PIC18FXX2 Rev. B3/B4 Silicon/Data Sheet Errata

The PIC18FXX2 parts you have received conform functionally to the Device Data Sheet (DS39564B), except for the anomalies described below.

Clarifications/Corrections to the Data Sheet:

FIGURE 1: PINOUT DIAGRAM FOR DEVICE#, 44-PIN QFN PACKAGE

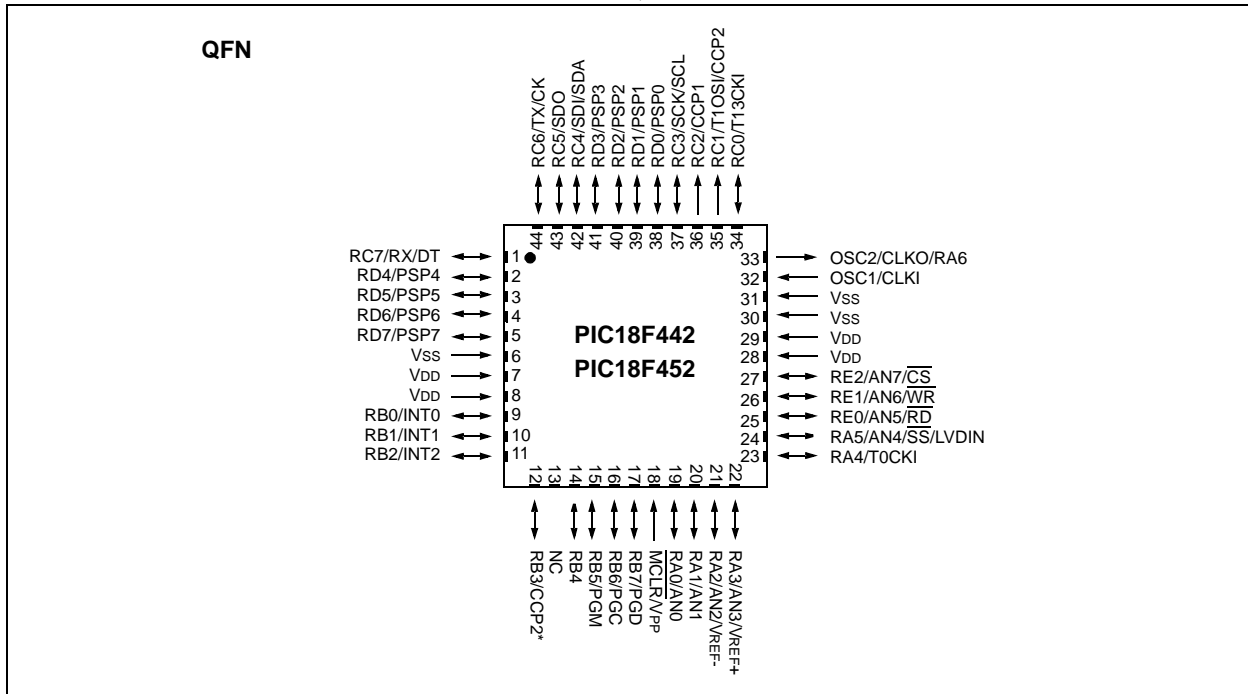
PIC18F442 and PICF452 devices are now offered in 44-pin, near chip-scale micro lead frame packages (commonly known as “QFN”). This packaging type has been added to the product line since the latest revision of the Device Data Sheet.

1. The “Pin Diagrams” on pages 2-3 of the Data Sheet are amended with the addition of the 44-pin QFN pinout, shown in Figure 1.
2. Table 1-3 of Section 1.0 (“Overview”) is replaced with an updated version which adds a column for QFN pin assignments. A row is also added for previously unlisted NC pins. All new information is indicated in **bold**.

FIGURE 3: 44-PIN QFN PACKAGE (DRAWING 1, PACKAGING)

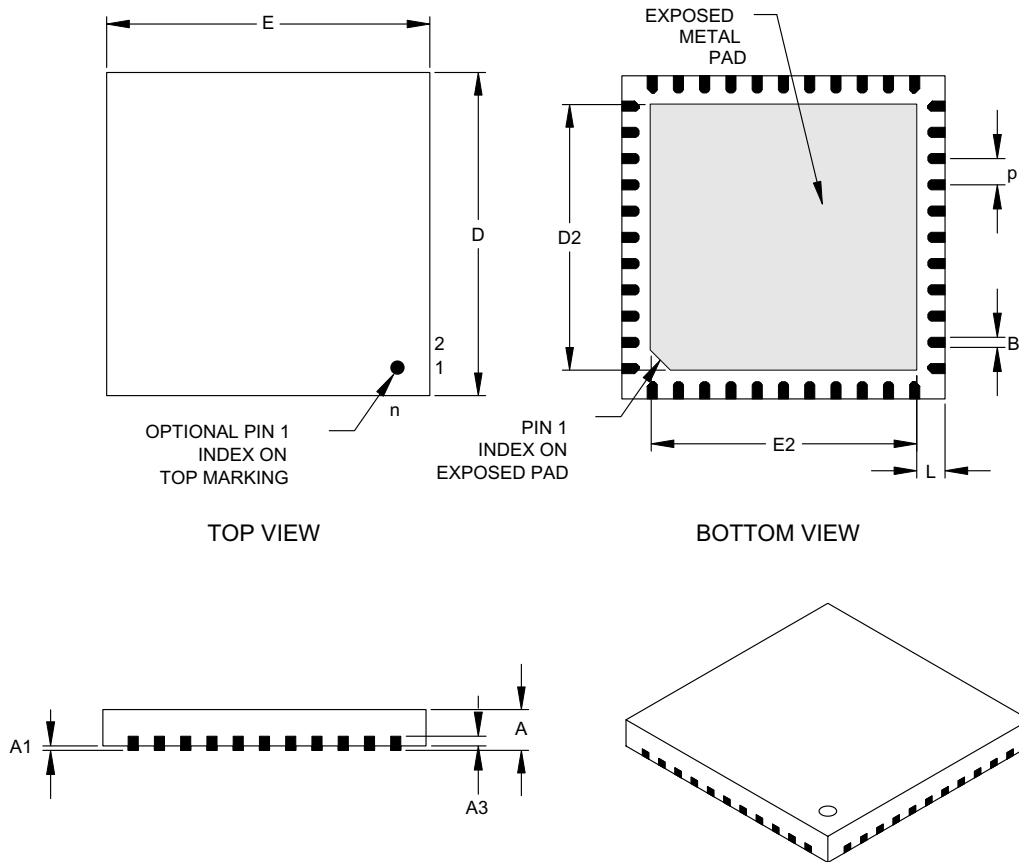
3. Section 24.1 (“Package Marking Information”) is amended to include a marking template and example for 44-pin QFN devices. These are shown in Figure 2.
4. Section 24.2 (“Package Details”) is amended to include the mechanical drawings of the 44-pin QFN package and its solder mask diagram, following the existing drawings. These are shown in Figure 3 and Figure 4, respectively.
5. In the “Device# Product Identification System” (page 329), the “Package” options are amended to include the new line item:
